DESIGN REVIEW III OREGON SQUARE

November 5, 2015

AMERICAN
ASSETS
TRUST

CAMPUS COMMENTS TO ADDRESS - POST DR II

PREFERRED - GROUND FLOOR PLAN

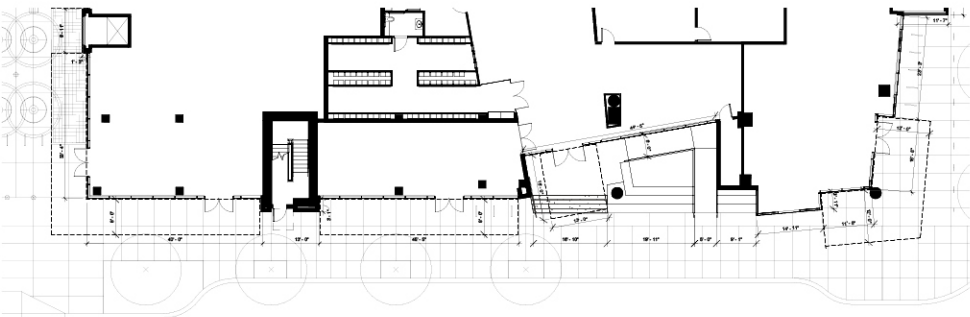
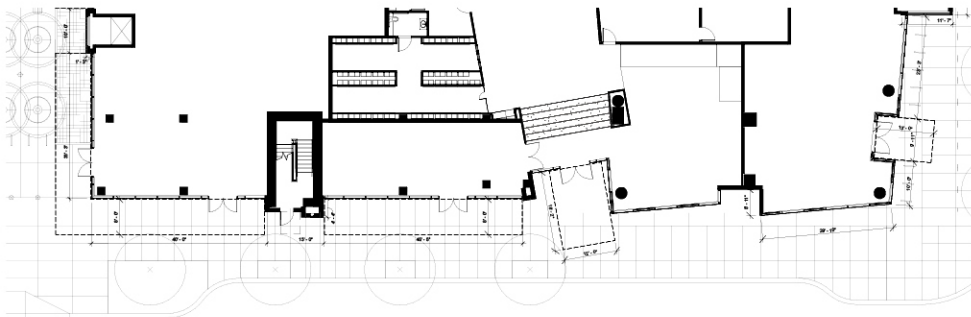
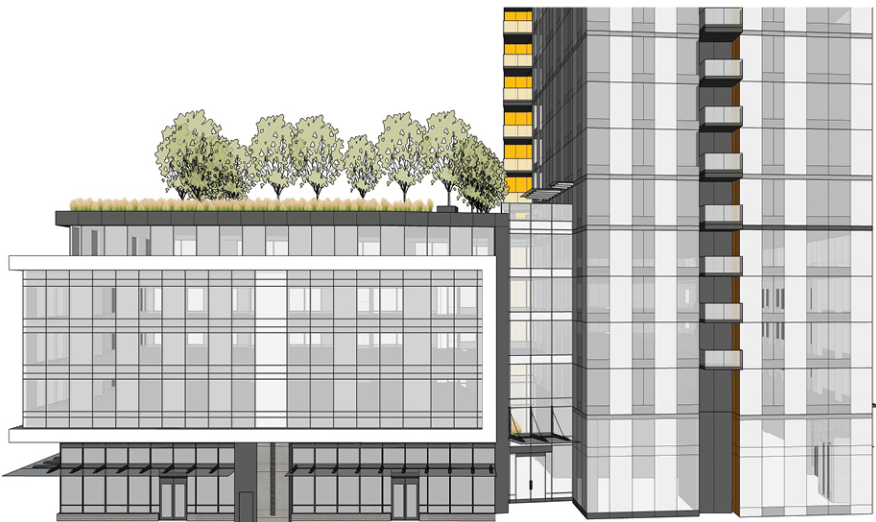
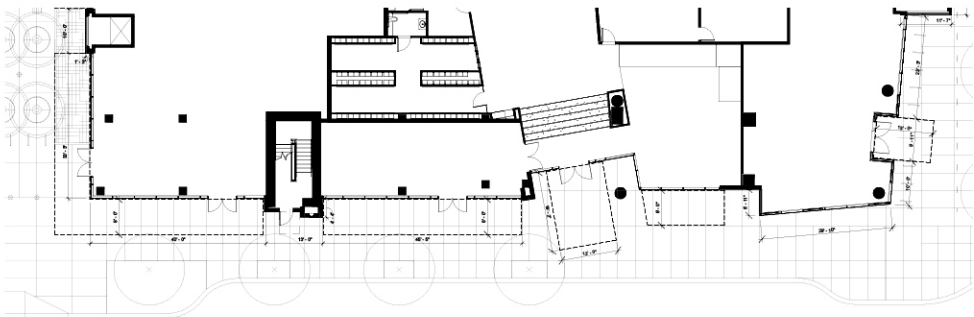
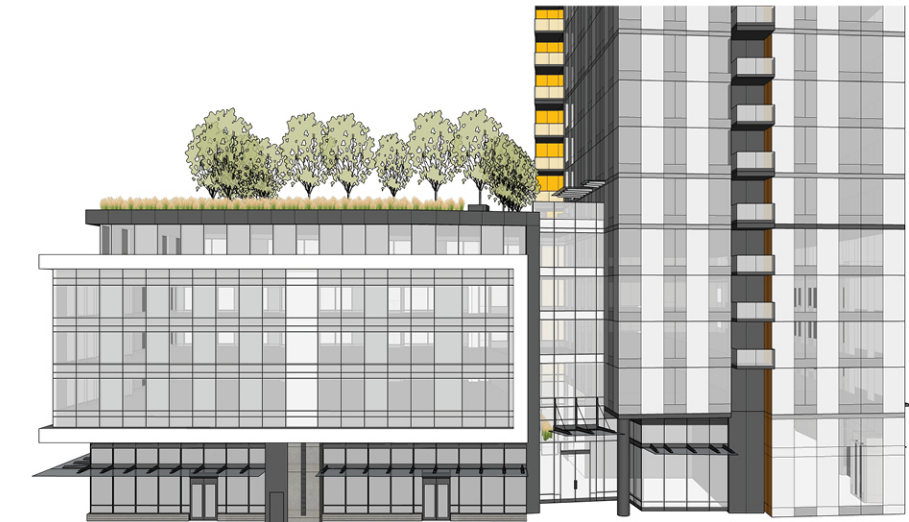
MAIN ENTRY TO BUILDING FEELS CONSTRICTED.

GBD: The entry condition has been studied (studies included in Appendix B). The Southern lobby entrance now wraps around to align with the tower balcony wall, allowing room to internalize the ramp and keep the entry on grade with the sidewalk.

This lobby is a separate, glassy element that gives clear sightlines into the plaza. The southern lobby entrance wraps around to align with the tower balcony wall, allowing room to internalize the ramp and keep the entry on grade with the sidewalk.

Preferred - View of Southeast Corner and Pass-Through Plaza

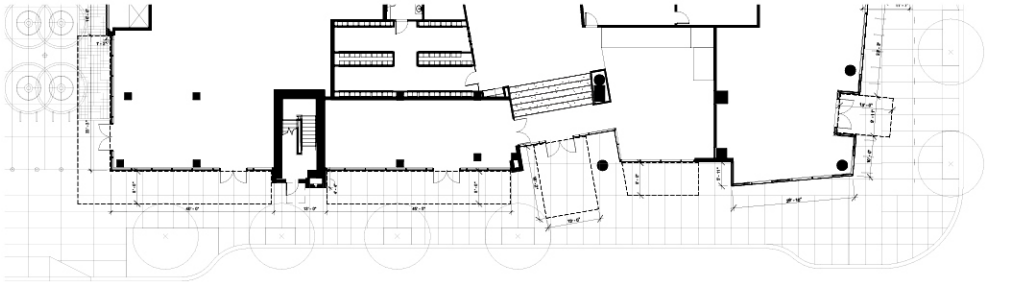
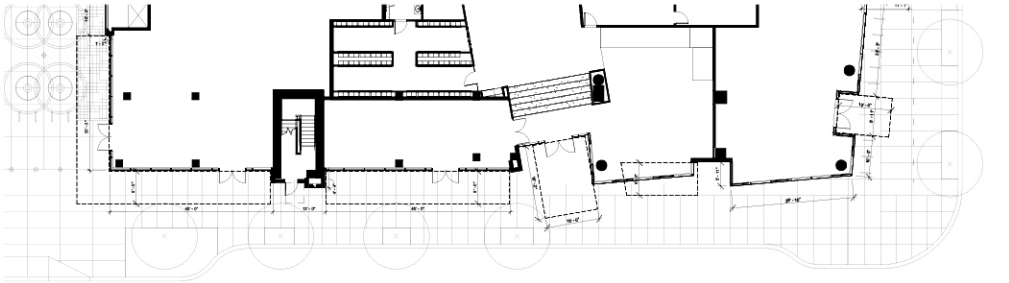
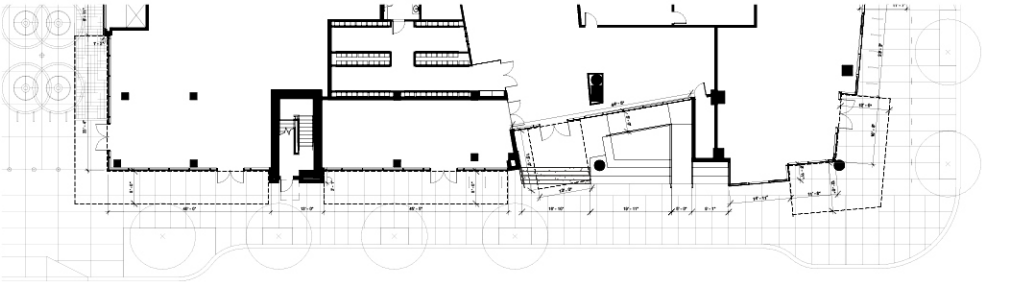
ONE MORE PASS IS NEED ON HOW THE PODIUM EMETS THE TOWER AT THE SOUTHEAST CORNER.

GBD: The precast concrete of the podiums has been changed to glass in order that both podiums could have more of a glassy reading and be more similar to the tower. The southeast corner comes down to the ground as a contrasting entry element to the main lobby.
